# Service Bulletin

S.B. No: 188

**Title:** INSPECTION FOR RUDDER PEDAL CLEARANCES BETWEEN RUDDER PEDALS AND THE AIRCRAFT STRUCTURE AND COMPONENTS ALSO INSPECTION FOR GROUND TOWING DAMAGE.

**Applicability:** T67B, T67C series, T67M (excluding works no. 1999), T67M-MkII and T67M200 (excluding works no. 2264 & 2265).

**RUDDER BAR END FLOAT AND ITS SUPPORT BRACKET**

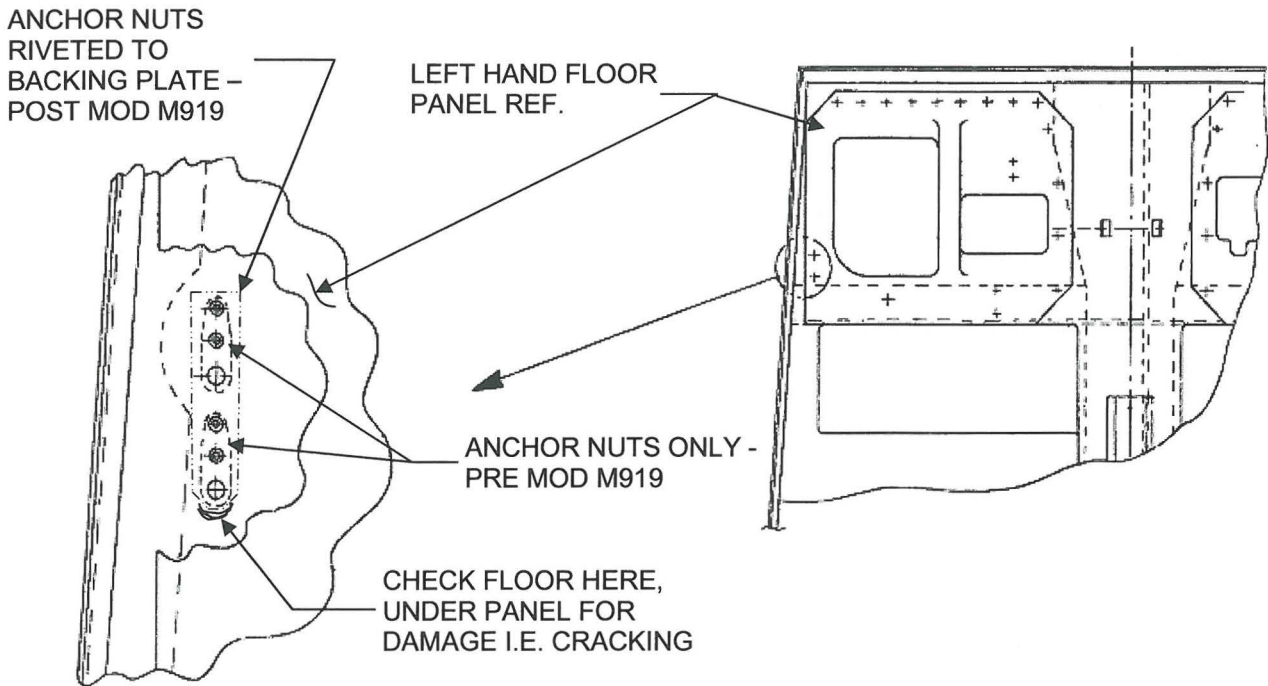
3. Check rudder pedal bar end float is no greater than 0.8mm. Acceptable end float is 0.0mm to 0.8mm. If end float is greater than 0.8mm then rectify end float IAW paragraph 13. Refer Figure 1.

13. Referring to Figure 1 ensure at each rudder bar pivot position that there is one spacer T67M-45-507 OR one off washer 126-23-748 and up to a maximum of two off washers 126-23-749, i.e. 3 washers maximum.

If end float greater than 0.8mm, then 1 off packing washer may be added at each pivot position as required, i.e. 126-23-105 washer or 126-23-748 washer or 126-23-749 washer.

If packing washers are required on the right hand rudder bar (T67M-45-259), then the packing washer, (or the thicker washer if a thick and thin washer are required) should be placed at the outboard pivot. When end float of 0.8mm maximum achieved ensure that the brake cylinders are not subject to undue side load. If in doubt contact SACL

FIGURE 3

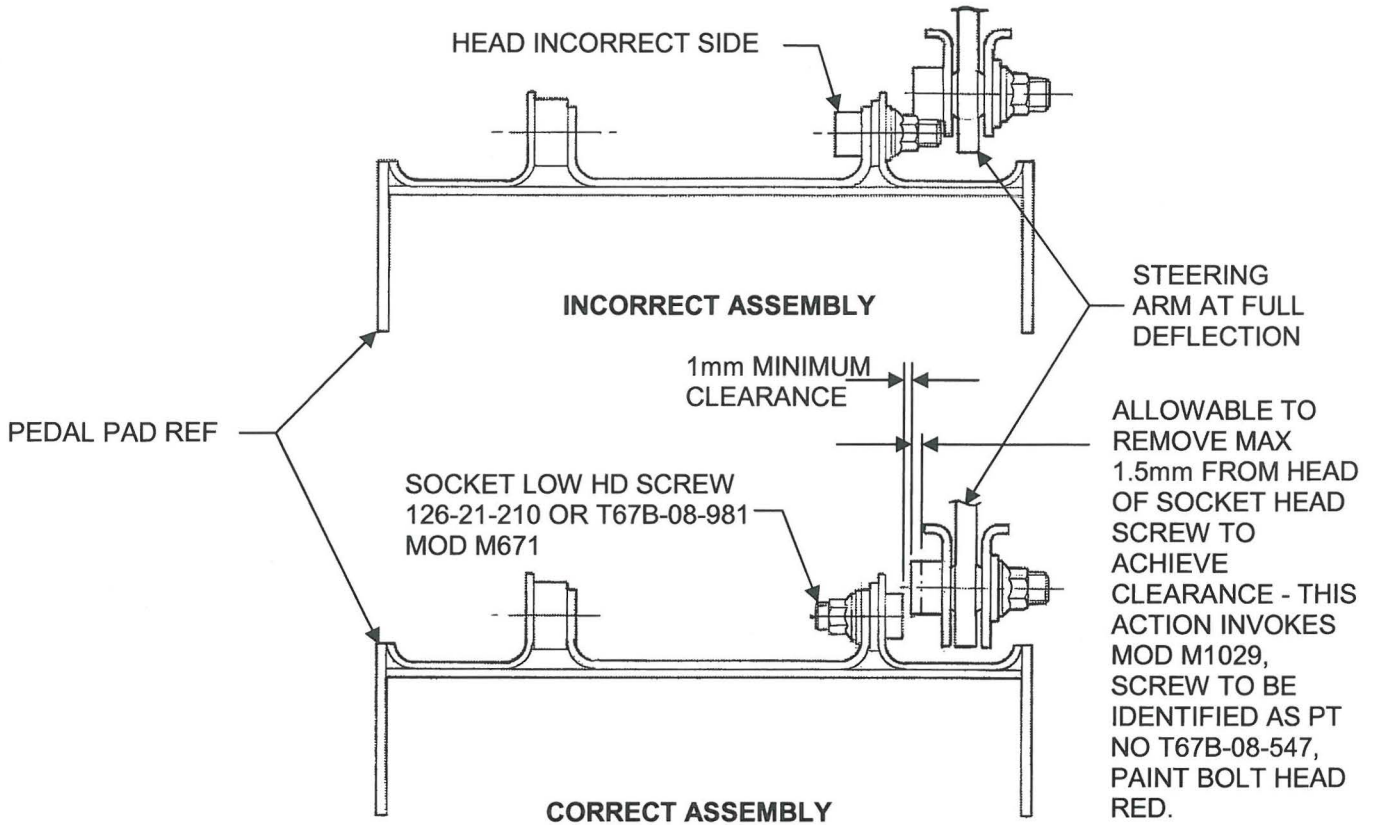
8. Check the remaining rudder bar support brackets, ref. Figure 3, are square to floor and are not "lozenged" and there is no deformation to their bases, reference Figure 1. If any bracket is found to be suspect replace with new item. Check floor under any damaged support bracket by removing panel. Ensure washers and brackets are correctly assembled refer paragraph 7 above. Inform SACL of any damaged bracket or additional floor damage. Assemble item as per paragraph 7 and ensure end float is as stated in paragraph 13. Ensure bonding leads are correctly fitted, carry out bonding check refer relevant aircraft's Maintenance Manual. Ensure correct length screws for attaching the rudder bar support brackets have been fitted in the correct positions, refer Figure 3.

18. Upon completion of rudder movement set-up ref. Paragraph 16 above. Ensure minimum clearances of trim panel to pedal side plates and rudder cable to pedal side plates are met Figure 3 refers. If necessary to obtain the required clearances, Mod M232 "Introduction of Rudder Pedal Packing for Increased Clearance of Surrounding Components" may be required to be invoked. Refer paragraph 13 for packing washers on rudder bar.

20. Ensure head orientation of rudder cable link bolt head is outboard, Figure 3 refers, this is a Low Pan Head bolt T67M-45-570 on Post Mod M471 "Introduction of Pan Headed Bolt on Rudder Cable Turnbuckles", aircraft.

27. Ensure rudder pedal carriage socket head caps screws are wire locked and bonded in with adhesive 126-51-024, use minimum amount, Mod M162 "Wire Locking of Rudder Pedals – Upper Pivots", refers. See Figure 3.

FIGURE 4

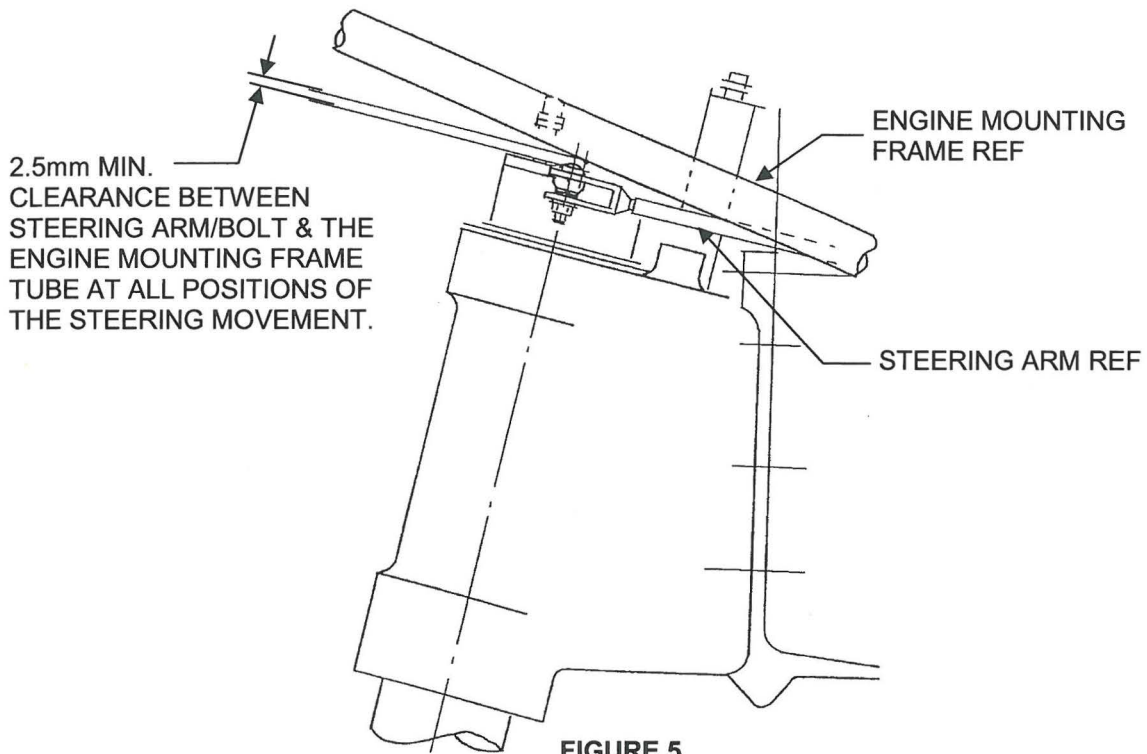
21. Ensure Pedal no 2 Pedal pad pivot bolt head height is less than 5mm and orientated as shown in Figure 4. A minimum of 1mm clearance is required, if not fit part no 126-21-210 or T67B-08-981, this invokes Mod M671 "Introduction of Low Head Rudder Pedal Pad Pivot Bolts – Pedal No. 2". If clearance is not still achieved check distance of steering arm from bar end, Figure 3 specifies. If the distance is incorrect, then return rudder bar to SACL for re-worked/new item. Alternatively if clearance of 1mm is still not achievable remove up to a maximum of 1.5mm from the steering arm screw this invokes Modification action M1029, Figure 4 refers, and paint modified screw head red.

FIGURE 5

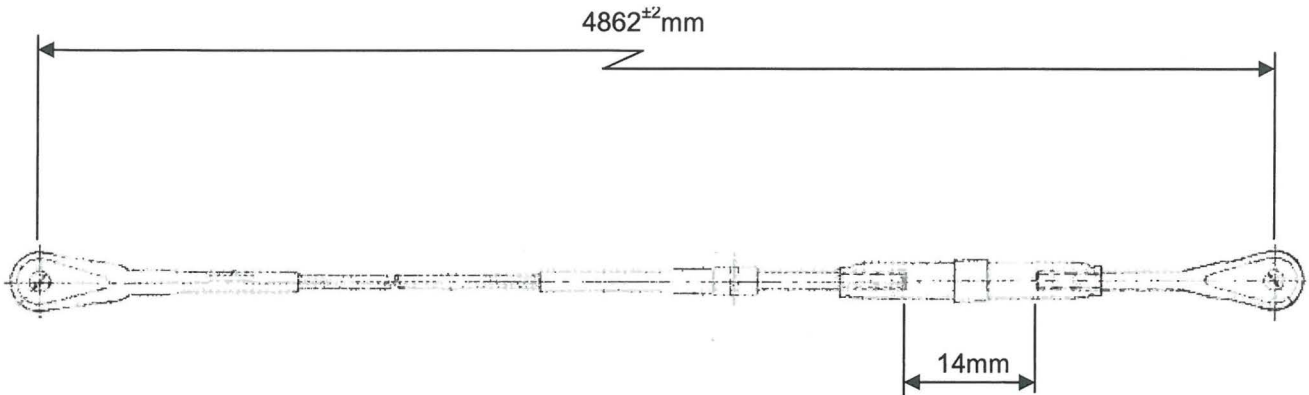
28. Ensure on aircraft fitted with the Fairey Hydraulic undercarriage, (Post Mod M468 or Mod M791), that there is a minimum clearance of 2.5mm with steering linkage to engine mounting frame, see Figure 5. Ensure there is no damage to engine mounting frame if clearance is less than 2.5mm. If engine mounting frame is damaged then aircraft must not be flown until damage is rectified, consult SACL. Also if clearance is less than 2.5mm embody Mod M575 "Introduction of Offset Steering Arm Pin – Ref Fairey Hydraulics Nose U/C", if Mod M575 is fitted and clearance is less than 2.5mm inform SACL.

FIGURE 6

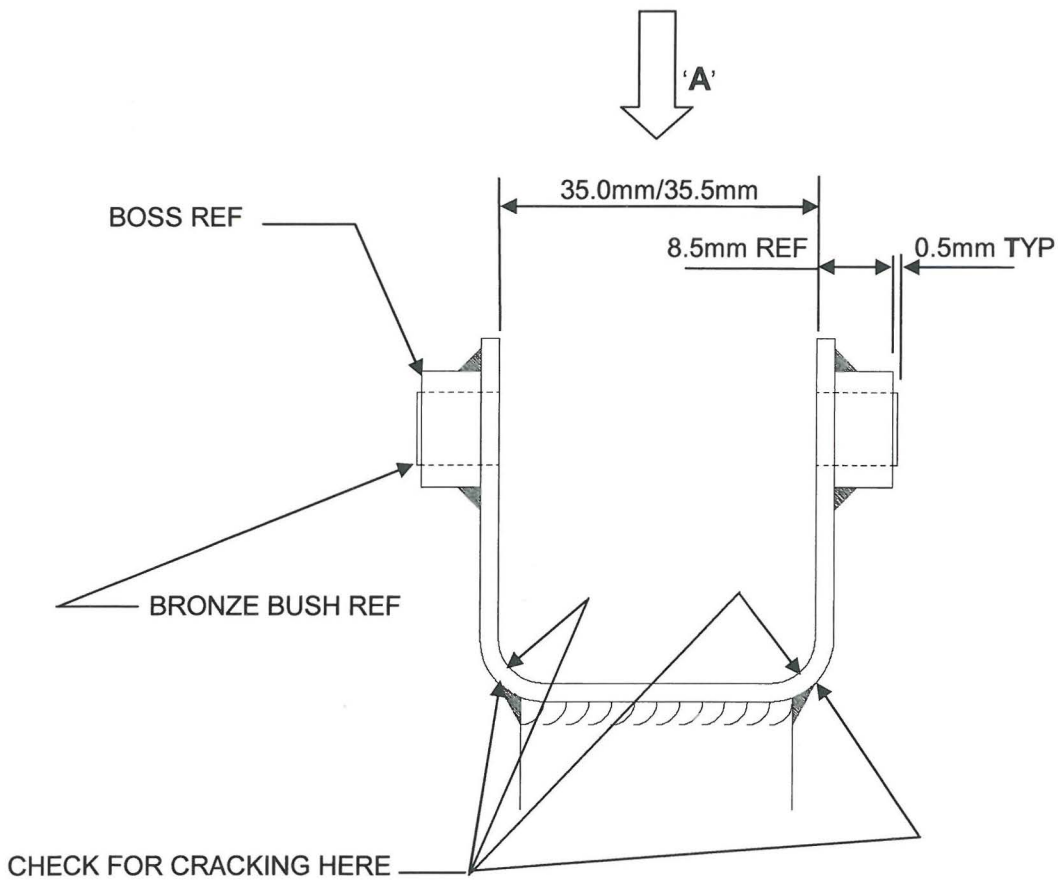
19. Ensure fuel pipe to rudder pedal slider clearance is met; refer relevant aircrafts Maintenance Manual Paragraph, 5.6.5.1, where relevant the minimum acceptable clearance is now to be 5mm. If clearance cannot be achieved then; i) remove Rudder Cable and check length, length should be 4862  $\pm 2$  mm, Figure 6 refers; ii) additionally check condition of rudder pedal assembly, refer paragraph 2, iii) if, i) and ii) do not achieve clearance remove fuel pipe, IAW relevant aircrafts Maintenance Manual, and re-orientate fuel pipe. If satisfactory clearance cannot be achieved inform SACL.

FIGURE 7

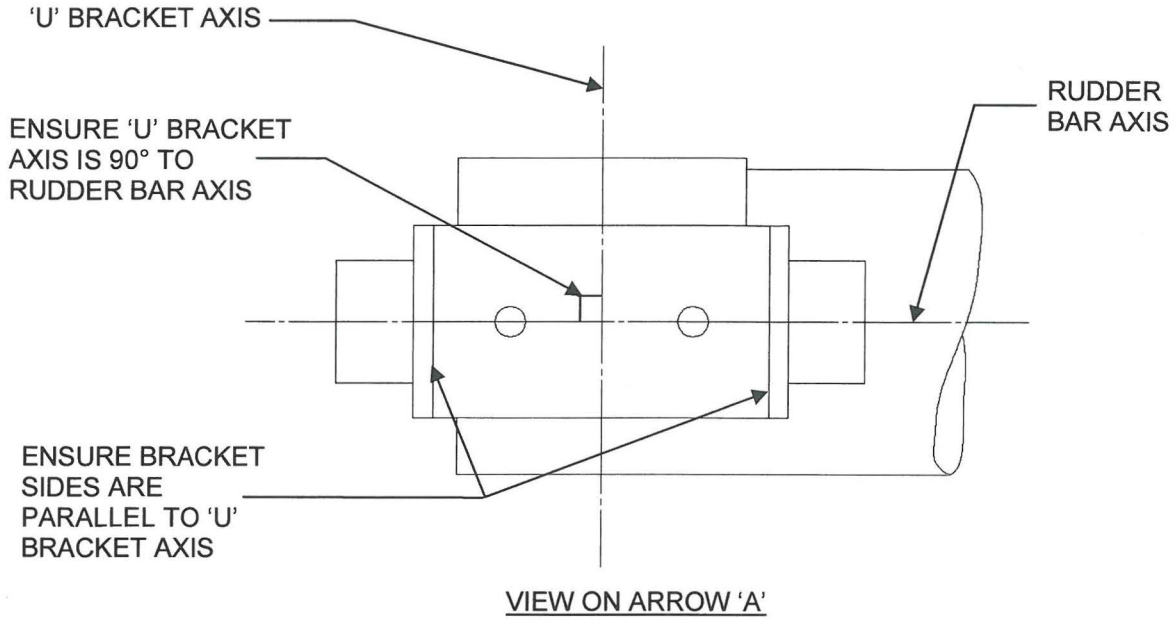
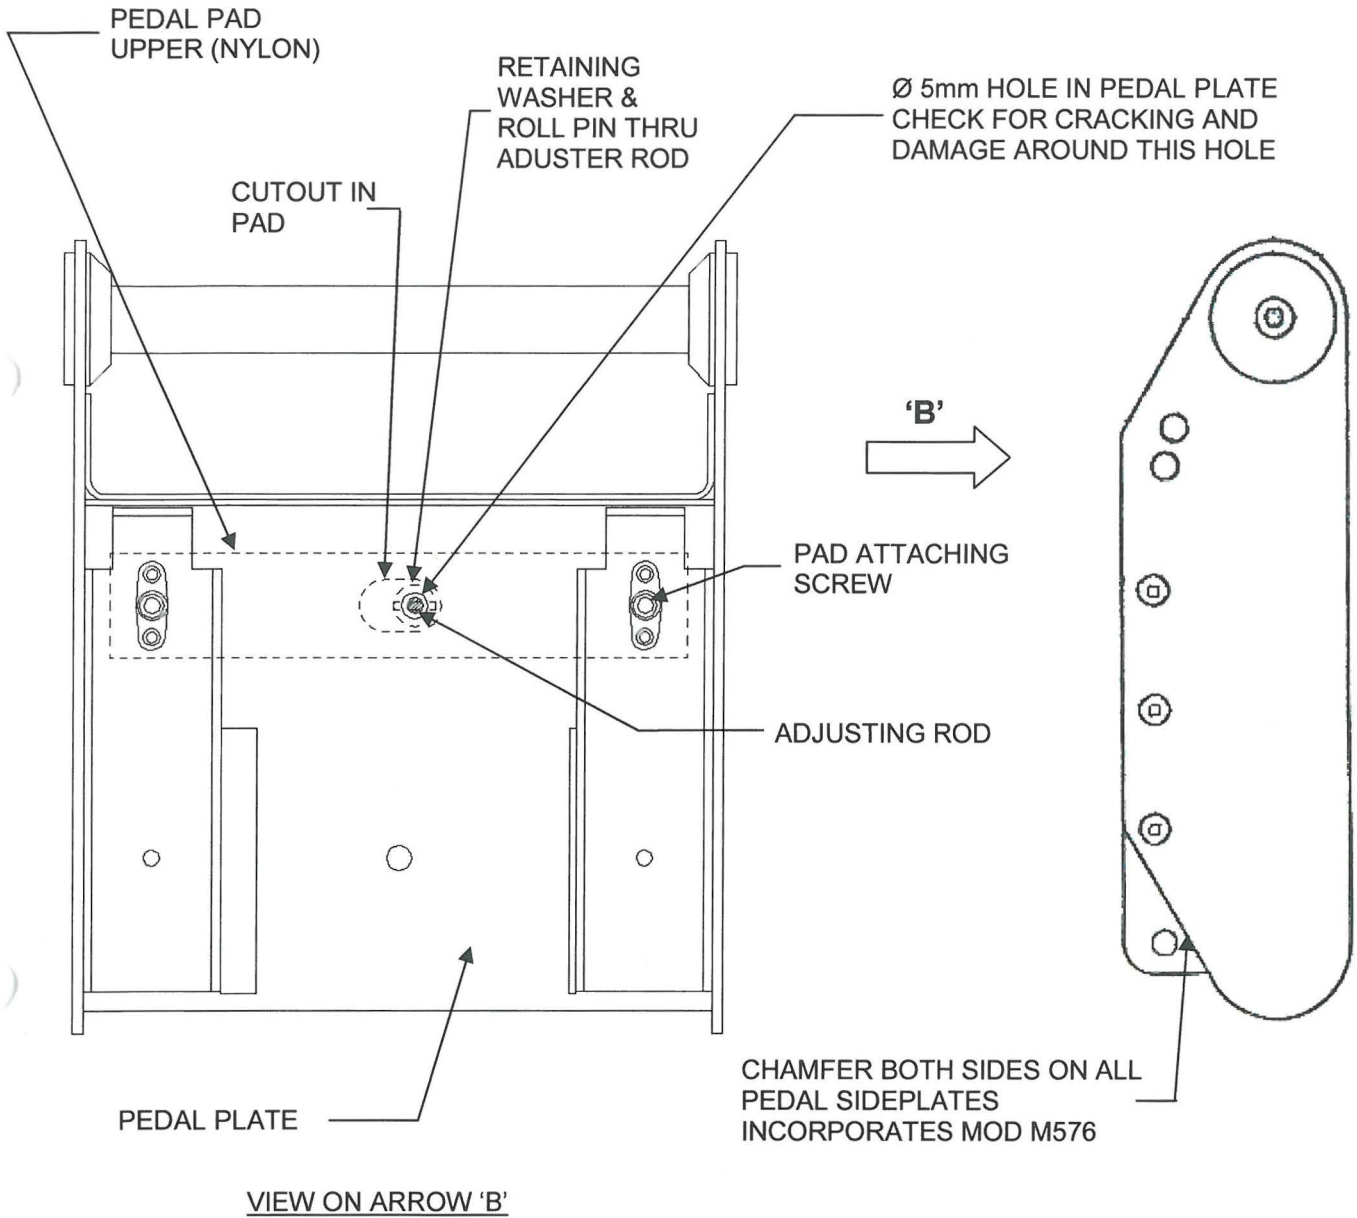
14. Check that the 'U' brackets are parallel and square to the rudder bar axis; Figure 7 View on 'A' refers. Also ensure the rudder pedal carriages have full and free movement. If binding is suspected then check the 'U' bracket internal dimension. This should measure 35.0mm to 35.5mm, also check that the pivot bush protrudes from its boss by 0.5mm. If the bracket internal dimension is greater or less, or if out of alignment then the bracket should be checked for cracking, refer Figure 7. If cracking is found then return rudder bar to SACL for rework. Finally check length of carriage pivot bolts, reference Figure 3, if binding is noted then replace bolts with bolt part number T67B-08-537 this introduces a bolt 15 mm long, measured from under head, and invokes Mod M808 "Introduction of Shortened Pivot Bolt to Rudder Pedal Slider Assembly Mounting". Also refer to SB130 Inspection of Rudder Pedals for Adjustment Restriction".

**FIGURE 8**

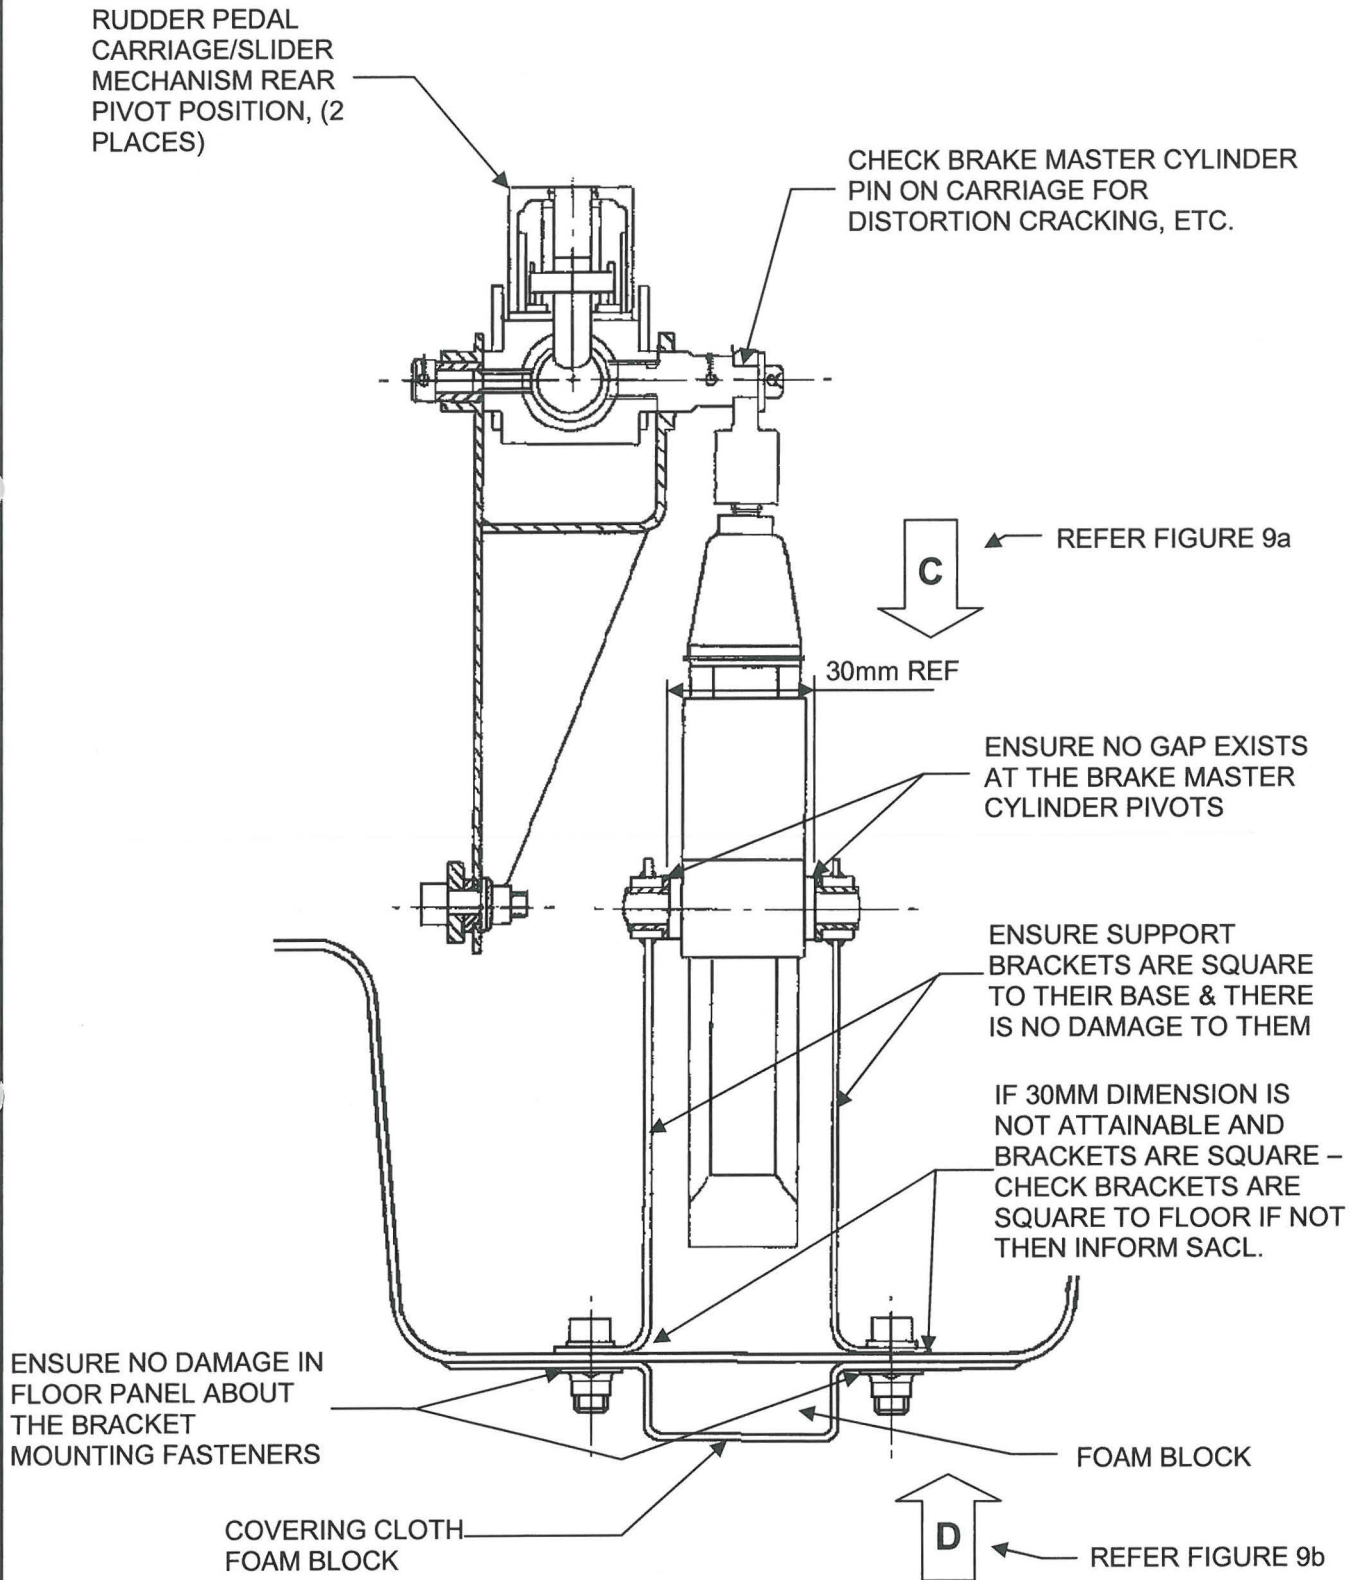
\*Mod M450 "Introduction of Improved rudder pedal sliders, adjusting mechanism and pedal incorrect assembly feature".
24. Ensure Mandatory Mod M576 has been invoked; CAA AD 013-05-94 refers. Pedal side plate should be as Figure 8.

25. Check structural integrity of pedal pad assembly especially around adjuster pushrod hole pedal plate, Figure 8 View on Arrow 'B' refers, if plate is cracked or damaged the pedal pad is to be repaired. Ensure riveting is secure, if rivets are loose then they have to be rectified. Contact SACL for new pedal pad assembly, materials and any applicable repair scheme.
